NPF-38-08

DESCRIPTION AND SAFETY ANALYSIS  
OF PROPOSED CHANGE NPF-38-08

This is a request to modify the Technical Specifications to remove the Core Protection Calculator (CPC) Type I and Type II Addressable Constants, as approved by the NRC Core Performance Branch in April, 1985.

FIGURE 3.2-1a.

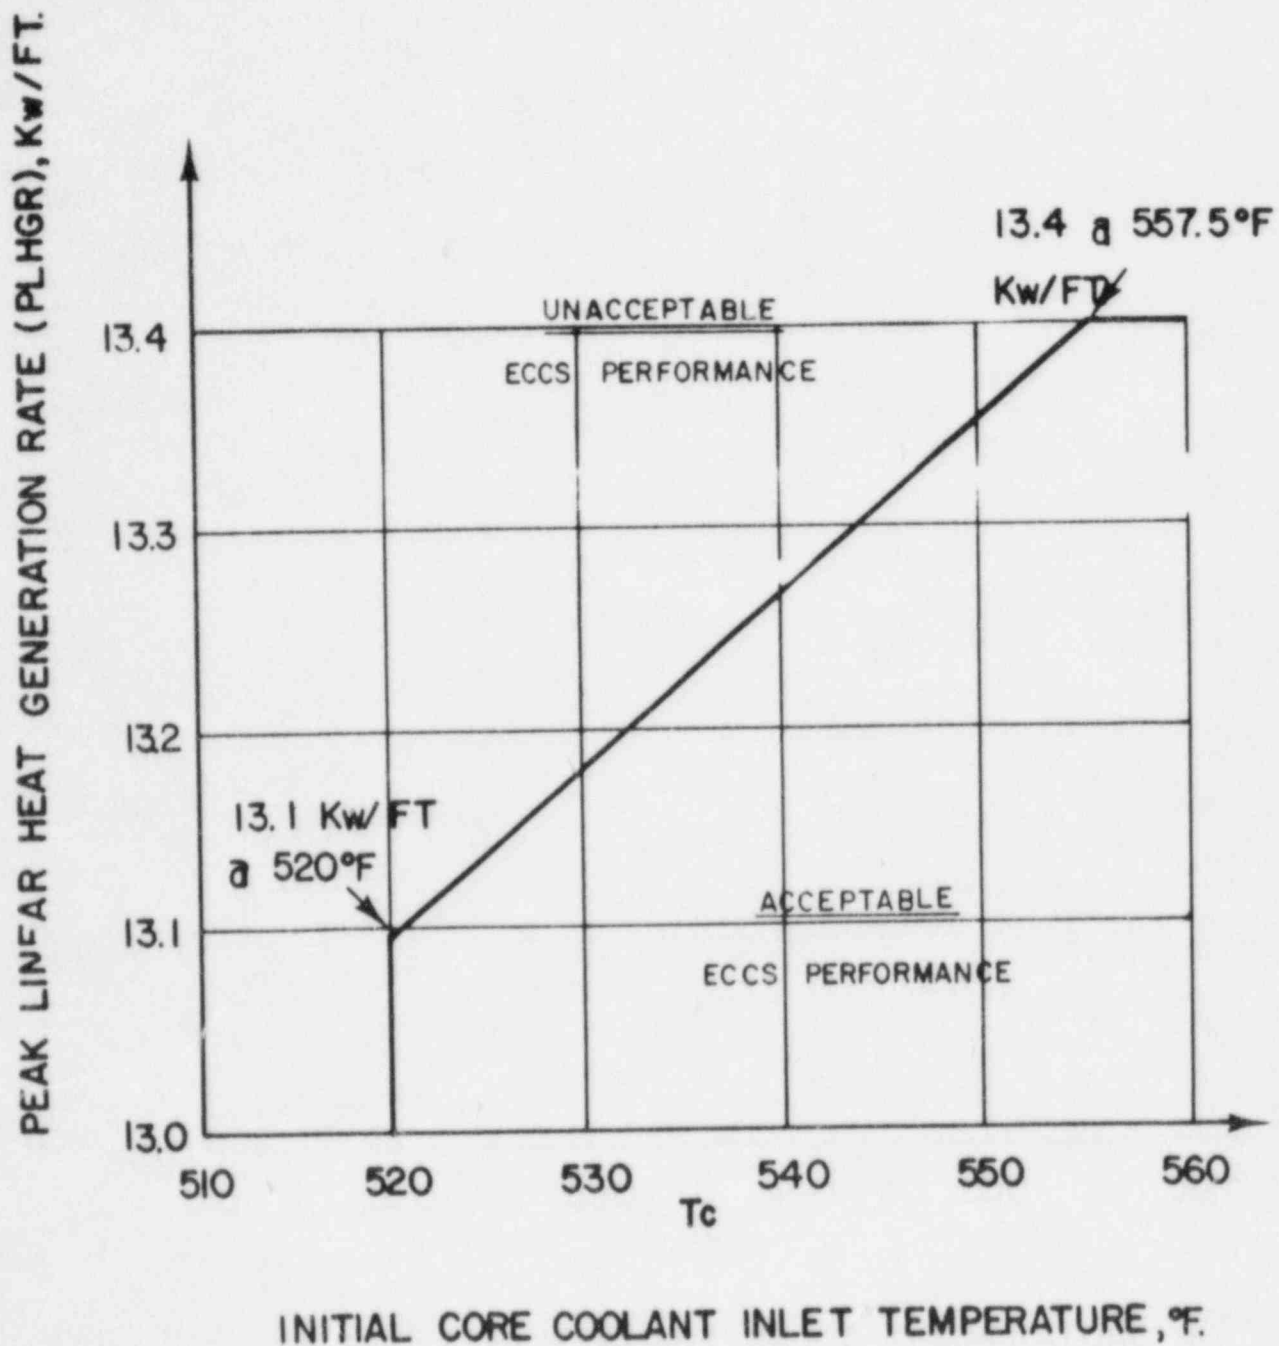
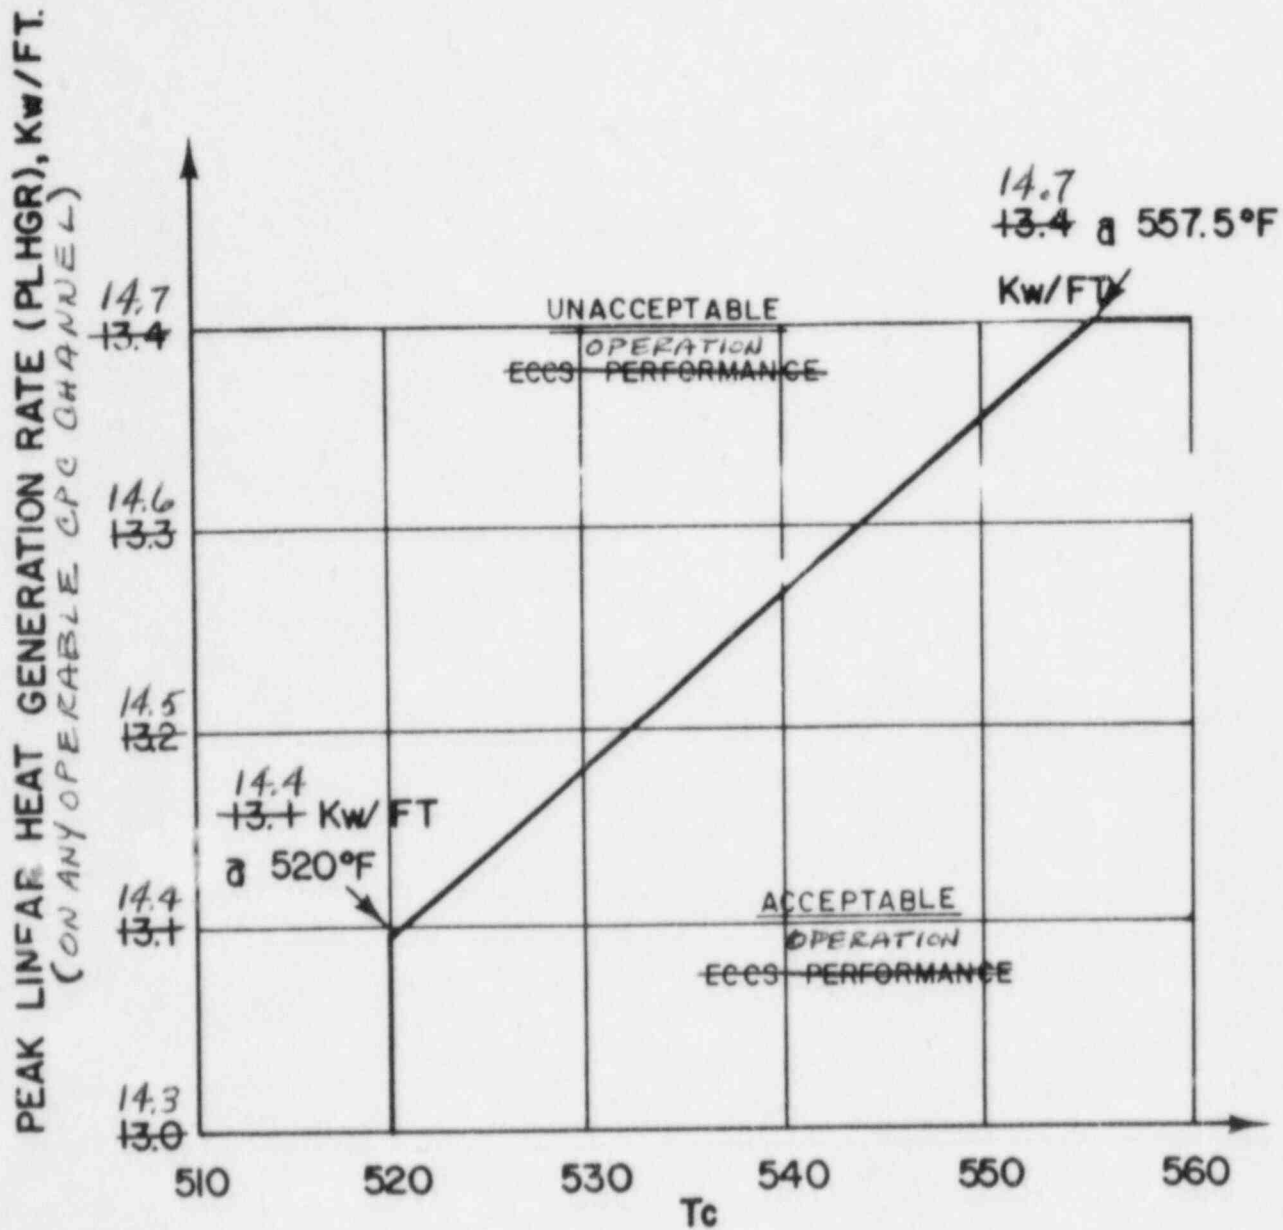
The proposed change will revise Technical Specifications 3.2.1, "Linear Heat Rate", 3.2.4, "DNBR Margin", 3.2.7, "Axial Shape Index", and the associated Bases. The proposed change will also add Figure 3.2-1a "Allowable Peak Linear Heat Rate vs Tc for COLSS Out-of-Service"; delete Figure 3.2-2 "DNBR Margin Operating Limit Based on COLSS" and replace it with "DNBR Margin Operating Limit Based on CPC's (COLSS Out-of-Service, CEACs Operable)"; Revise Figure 3.2-3 "DNBR Margin Operating Limit Based on CPC's (COLSS Out-of-Service, CEAC Inoperable)"; and revise Action 6.b.1 of Table 3.3-1.

The additional uncertainty terms included in the CPC's for transient protection are credited in Figure 3.2-1a since this curve is intended to monitor the LCO only during steady state operation.

In addition, when COLSS is out of service and both CEAC's are inoperable, the 57% penalty applied automatically in CPC can be credited in the CPC linear heat rate calculation since it is required only for transient protection. In this case, Figure 3.2-1 is automatically maintained by the CPC trip limit.

FIGURE 3.2-2

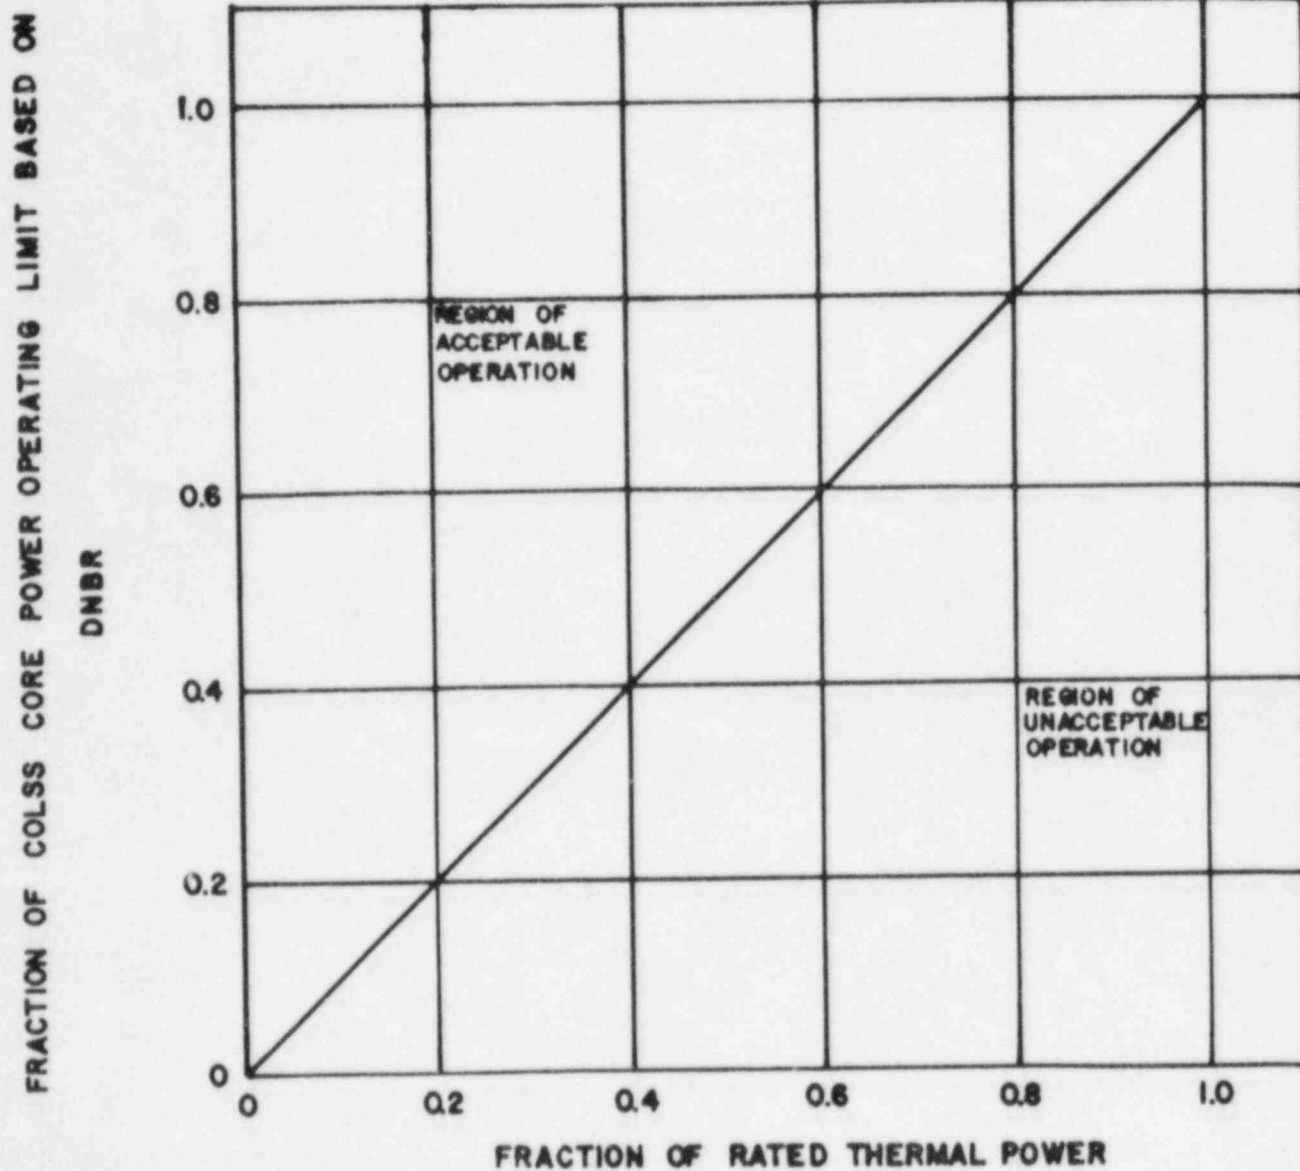
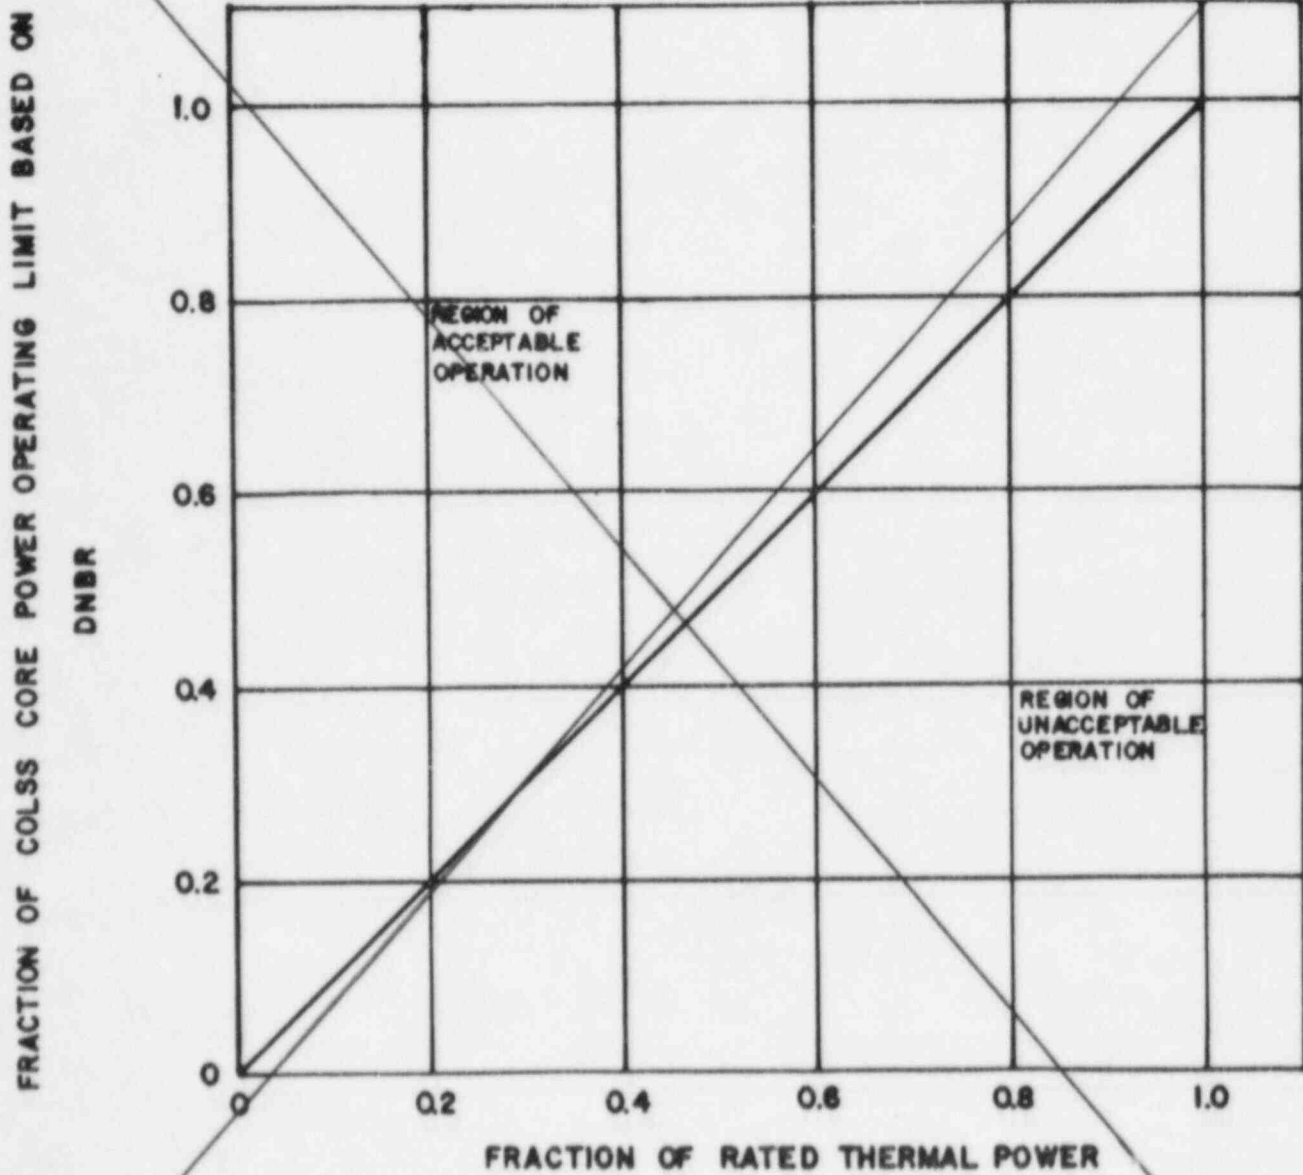
In this case the proposed change described above is similar to Example (vi) in that revising Technical Specifications 3.2.1, 3.2.4 and 3.2.7; revising Figure 3.2.3 and Action 6.6.1 of Table 3.3-1; replacing Figure 3.2-2; and revising the associated Bases is clearly within all acceptable criteria specified by the NRC for digital plant protection systems in general and the CPC in particular. Additionally, the changes provide for less impact than allowed by Example (vi) because no safety margins are reduced.

DELETE
